Your Ref SSD-9579147

COUNCIL SUBMISSION

NOTICE OF EXHIBITION OF ENVIRONMENTAL IMPACT STATEMENT FOR THE REDEVELOPMENT OF PENDLE HILL HIGH SCHOOL (66 BINALONG ROAD, TOONGABBIE)

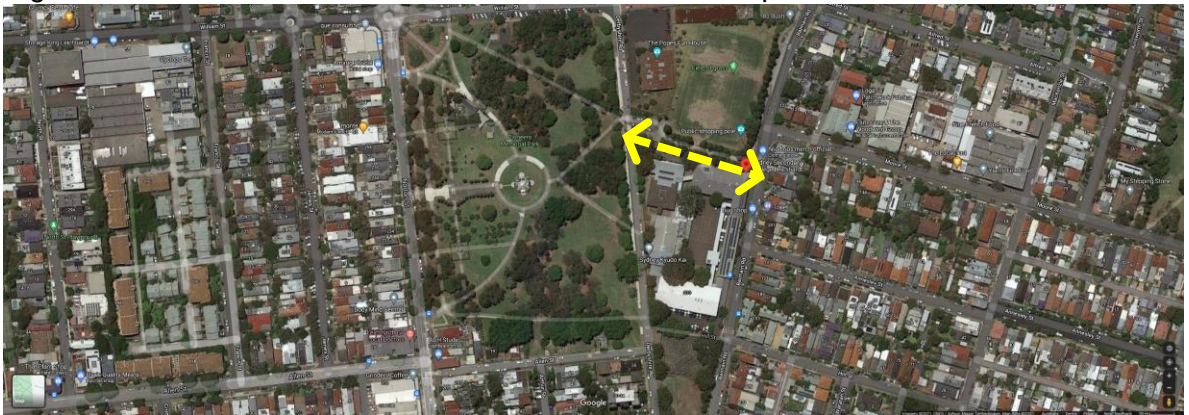
The long-term master plan (Architectus) for the school included in the Design Report indicates a street along the southern boundary between Cornock Avenue and Binalong Road also linking to Knox Road. The submitted documentation does not include this as a feature in the current scope of works. It is the opinion of Urban Design that if this is not developed now it is unlikely to be developed later.

Ideally this link should be a formed laneway 9m wide (6m vehicular + 3m pedestrian & cycle shareway) that can accommodate service and emergency vehicles and has visual surveillance from neighbouring properties. This laneway may be closed to regular traffic with bollards but should otherwise read as a public street.

- A. A direct, signposted, well-lit and publicly accessible pedestrian through link (min 3m wide) in the non-secure/non-fenced area of the school grounds connecting Binalong Road, Knox Road and Cornock Avenue is recommended (aligned with Architectus' Master Plan). This link should be designated as a Right of Way (ROW) in the land title.
